PROPOSED CONCRETE QUAY

V.M.R.C.#17-0009
 & REVISED
 1-25-17

Received revised
 2-1-2017 jde
 NAO-2007-0009
 VMRC 17-0009

LOCATION: COCKRELL'S CREEK SFD. & DELI - REEDVILLE AREA, PARCEL 305, FAIRFIELD DISTRICT TAX MAP 38-1, NORTHERN HUNTERLAND CO., VA.
 PURPOSE: VESSEL LOADING, UNLOADING AND MAINTENANCE
 SHT. 1 OF 4 DATE: 1-2-17 BAYSHORE DESIGN, LLC - KINSALE, VA

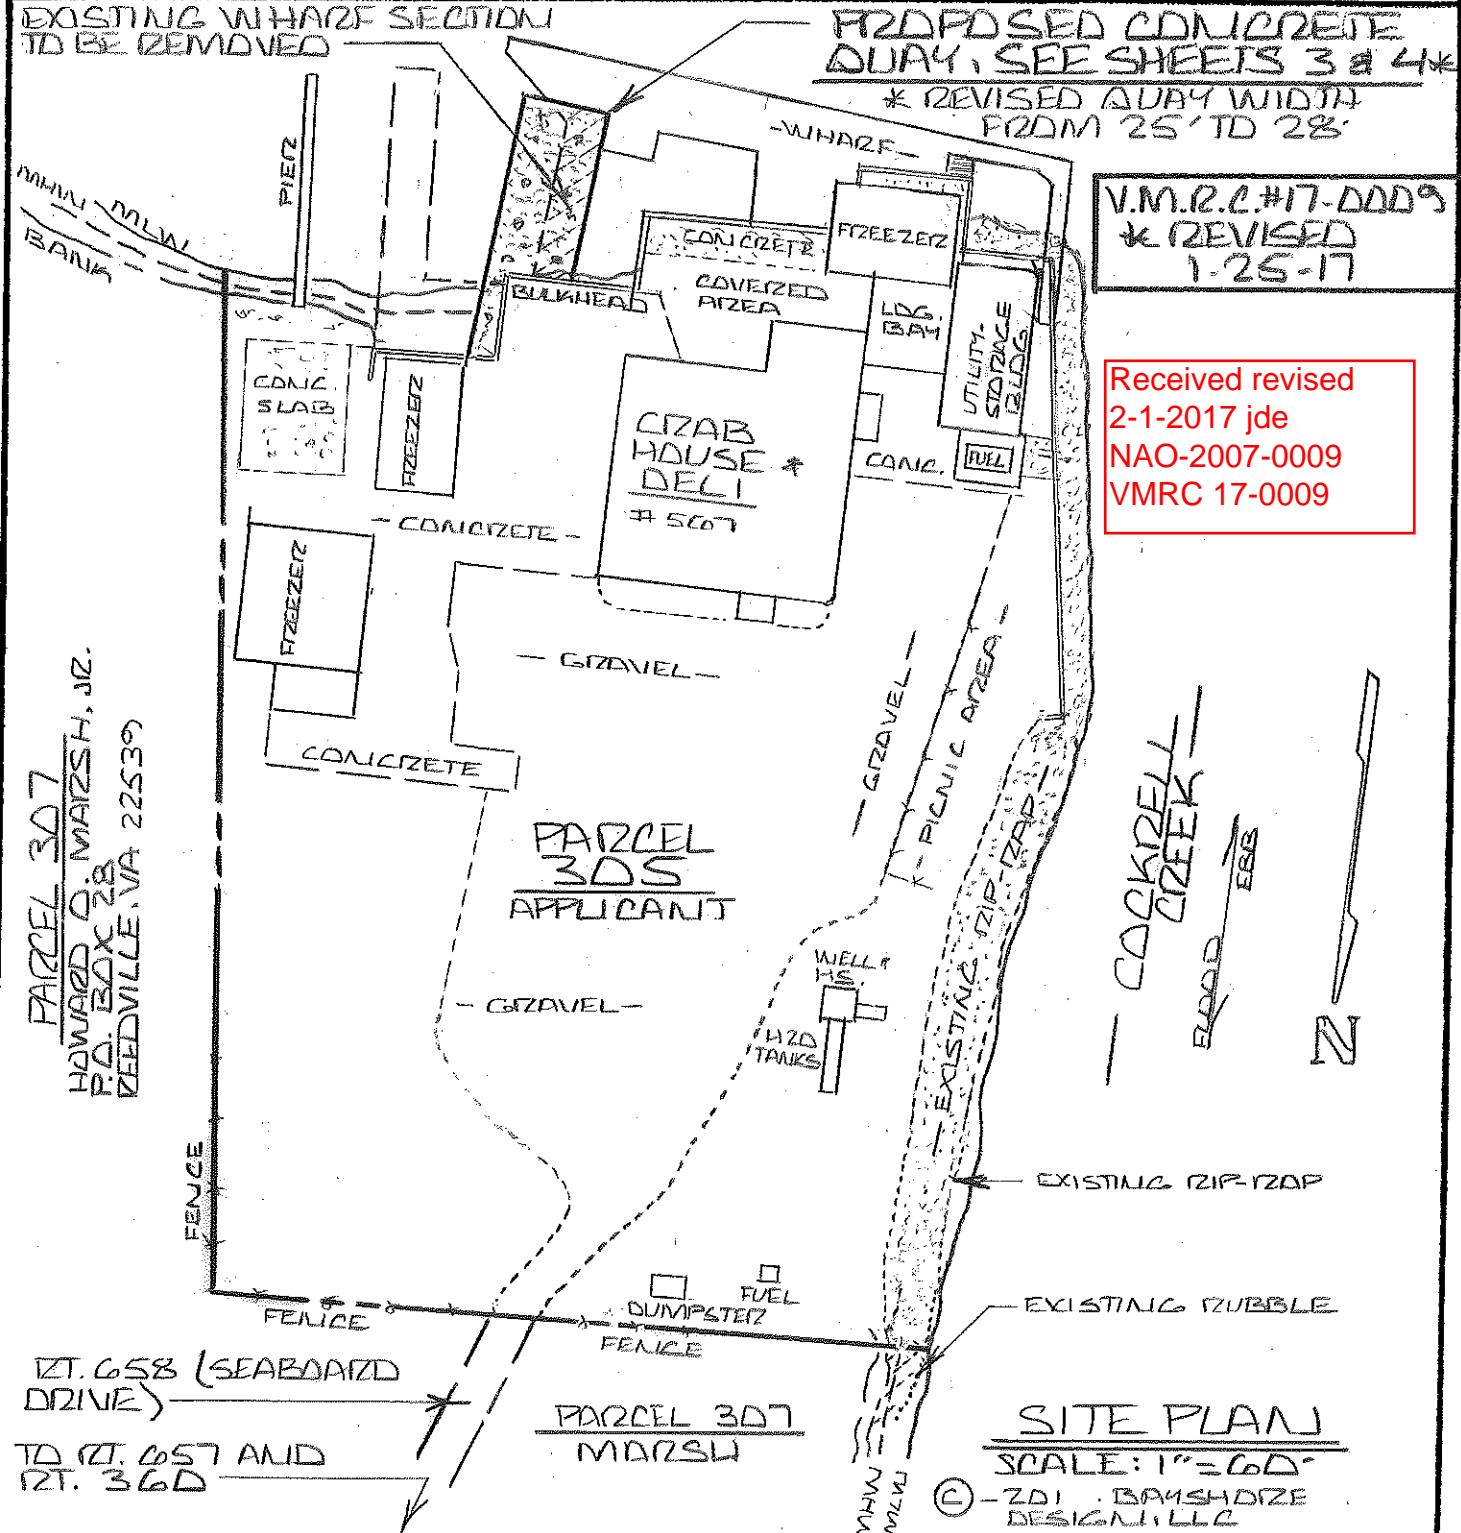
* REVISED QUAY WIDTH
 FROM 25' TO 28'
